TO: MODIFIED BY EI 82-035 Director, EFFECTIVE 5/17/82 Preliminary Review Bureau PRELIMINARY REVIEW BUREAU SUPERSEDED BY EI 82-054 EFFECTIVE 8/13/82		ENGINEERING INSTRUCTION NEW YORK STATE DEPARTMENT OF TRANSPORTATION	
Distribution:		SUBJECT: REPLACEMENT CLAMPS FOR STEEL BRIDGE RAILING Subject Code: 7.35-2	
<input checked="" type="checkbox"/> Main Office <input type="checkbox"/> Regions <input type="checkbox"/> Special		Code: <u>E.I. 82-13</u> Date: <u>FEBRUARY 19, 1982</u> Supersedes:	
APPROVED: <i>E. V. Hourigan</i> <u>E. V. Hourigan, Deputy Chief Engineer (Structures)</u>

Director of Highway Maintenance
 Director Struct. Design & Const.
 STATE OF NEW YORK
 DEPT. OF TRANS.
 DIV. OF MAINTENANCE
 ST. BR. RAILING
 REPLACEMENT CLAMP
 DETAILS
 SCALE: 3/8" = 1" DWG. NO. SR-4

DETAIL #1

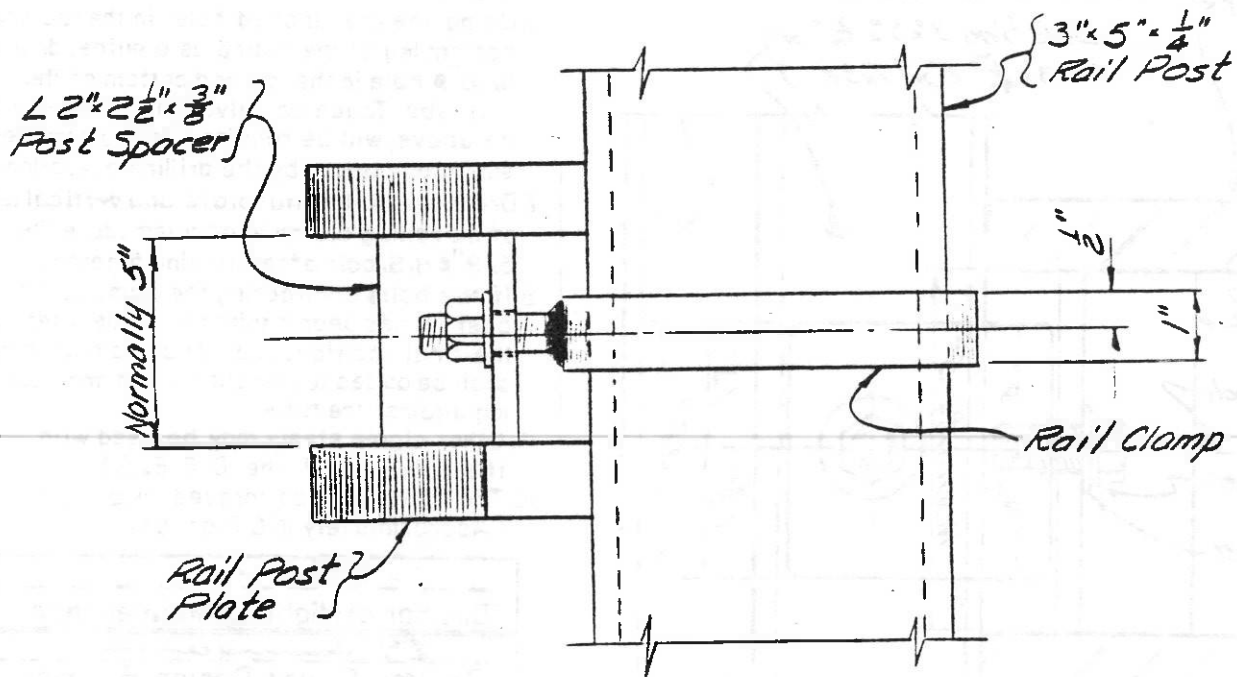
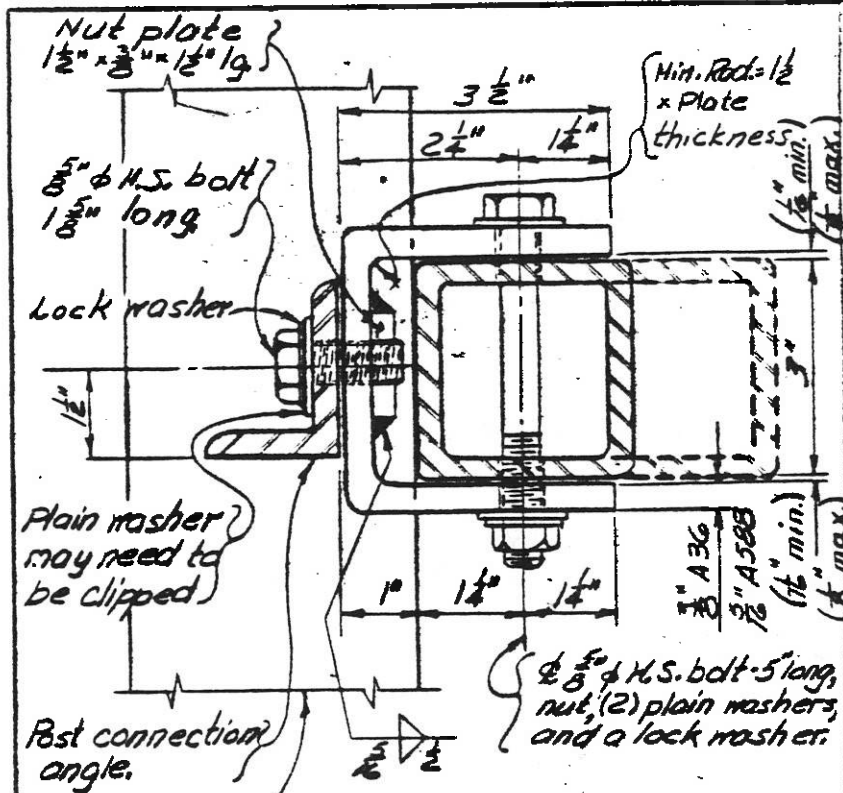
Several years ago, it was determined that the railing clamps used on two and four rail steel bridge railing installed between the mid 1960's and mid 1970's were a serious maintenance liability. (See attached Detail #1). Therefore, a new clamp was designed and made part of the standard details.

Effective immediately, rail clamps of the type depicted in Detail #1 shall be replaced by clamps built according to Detail #2 on all bridge rehabilitation contracts where they are encountered.

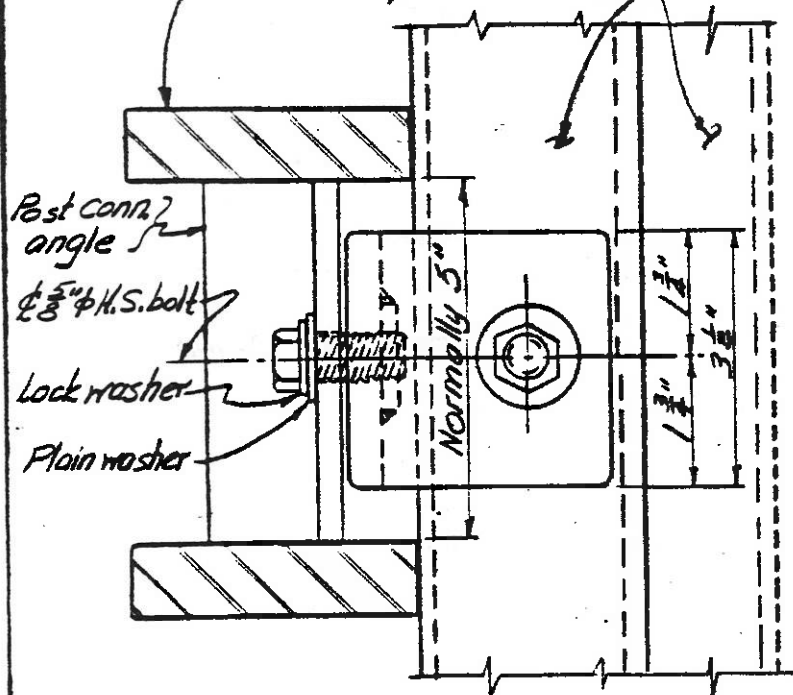
The new design cannot be used with the older railing systems mentioned above. Therefore, a modified version was developed (see attached Detail #2) for retrofitting existing systems with the inadequate clamp. A very similar clamp has been used by the Maintenance Division for several years. In addition, the details for the modified version (Detail #2) were informally distributed to Designers, on a job-by-job basis, in both the Main Office and Regions for use on various rehabilitation contracts.

Designers should assure themselves that the replacement clamps will fit the railing systems on which they are to be used. A railing system was recently encountered which was not built according to the Contract Plans. This fact was not noticed until the Contractor was ready to install the clamps. New modified clamps had to be ordered at the State's expense.
